SERVICE INSTRUCTION XK-SI003 Rev NC Page 1 of 5

SUBJECT: *PRESSURE SNUBBER INSTALLATION*

MODELS AFFECTED: *CCX-2300 S/N 0001 THRU CCX-2300 S/N 00062*

PURPOSE: *This document provides instructions for the installation of a pressure snubber on the Manifold Air Pressure and Fuel Pressure Transducers.*

Figure 2 - MAP Pressure Snubber

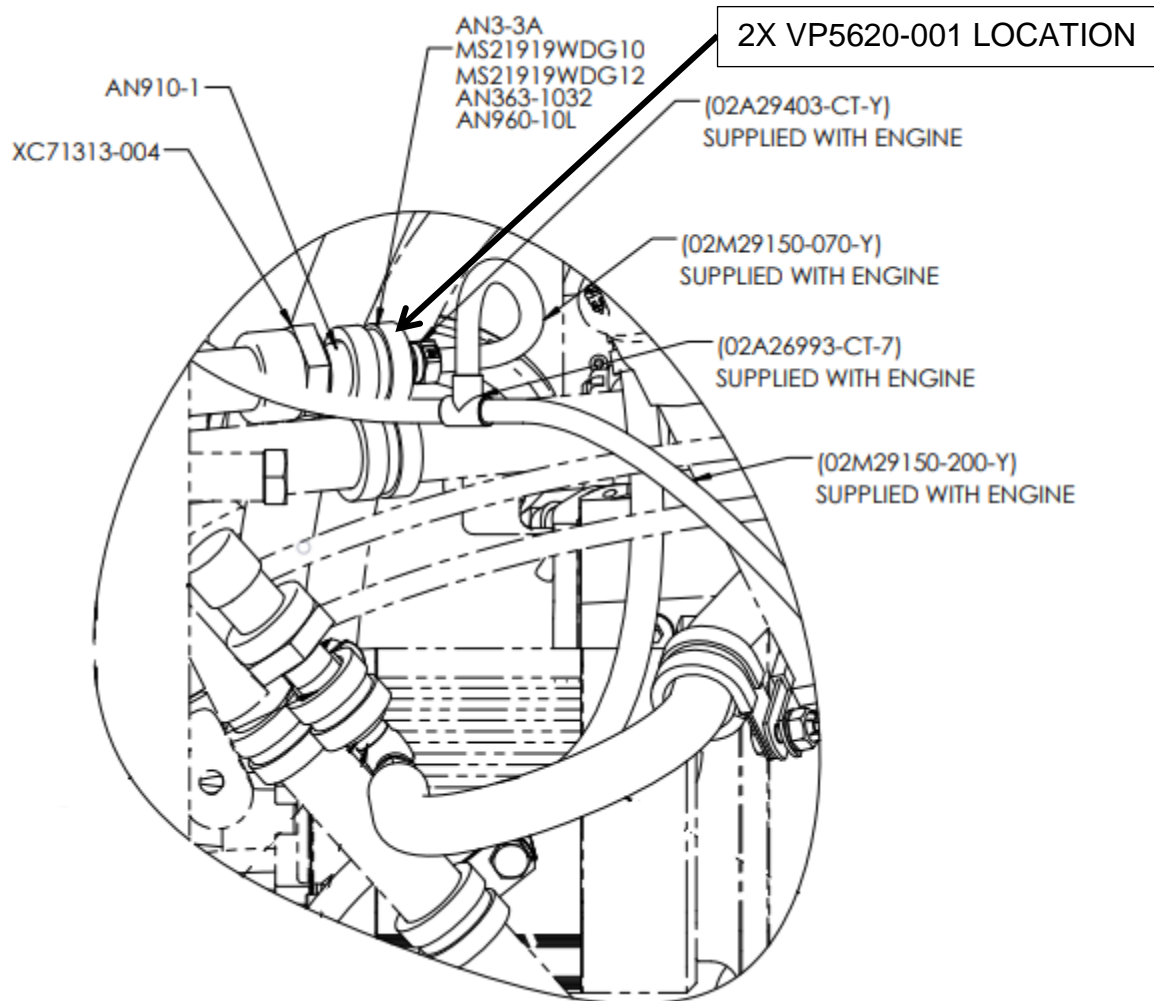
WARNING
 ENSURE THREAD SEALANT REMAINS CLEAR OF POROUS DISC ON MNPT
 END OF VP5620-001. THREAD SEALANT MAY CLOG DISC AND REDUCE
 FUNCTION OF TRANSDUCER

8. Install 2X VP5620-001 between AN910-1 and Lycoming-supplied brass hose barb (02A29403-CT-Y) at MAP transducer. Torque to 2-3 turns beyond finger tight. See Figure 2.

Figure 3 - Fuel Pressure Snubber

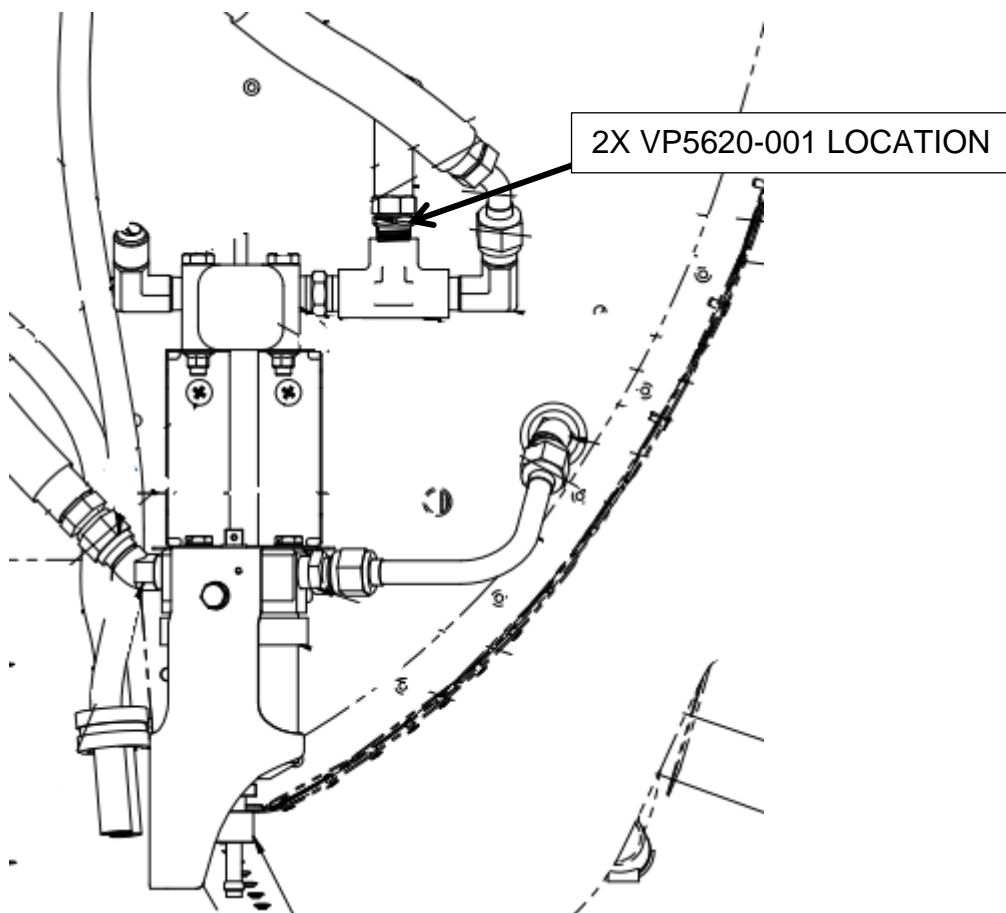
ENSURE THREAD SEALANT REMAINS CLEAR OF POROUS DISC ON MNPT END OF VP5620-001. THREAD SEALANT MAY CLOG DISC AND REDUCE FUNCTION OF TRANSDUCER

16. Install 2X VP5620-001 between AN912-1J and fuel pressure transducer. Torque to 2-3 turns from finger tight. See Figure 3.
